CDS Planning and Development Consultancy

Planning Application
44 Murray Road, Northwood, HA6 2YL
Planning Application 1787/APP/2025/1849

I have the pleasure of attaching a formal amendment package which responds comprehensively to the points raised during our discussions. This letter summarises the key amendments and provides additional clarification where further information was requested.

DMH 4 – Residential Conversions and Redevelopment

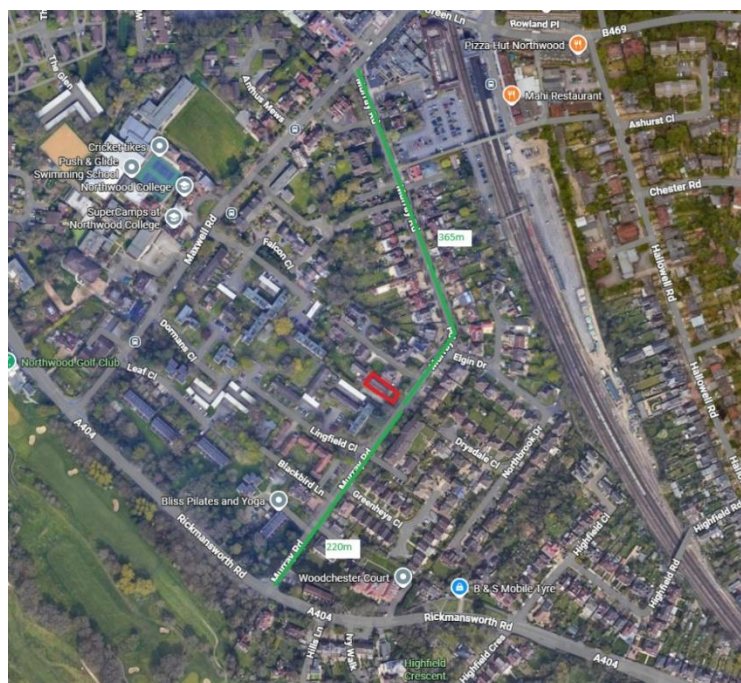
Properties Impacted

Murray Road has a total length of circa 574m.

For the purposes of assessing compliance with Policy DMH4, the entirety of Murray Road should be considered. The road has a total length of less than 1km and therefore falls within the scope of criterion (ii) of the policy.

Since 1984, only three properties along Murray Road have been converted or redeveloped from single dwellings into flats: Nos. 46, 14 and 48A. While planning permission was granted for No. 12C in 2022, that permission has since lapsed and therefore should not be included within the assessment.

This equates to approximately 2.2% of properties along Murray Road having been converted to flats since 1984, which is comfortably below the 10% threshold set out in Policy DMH4.
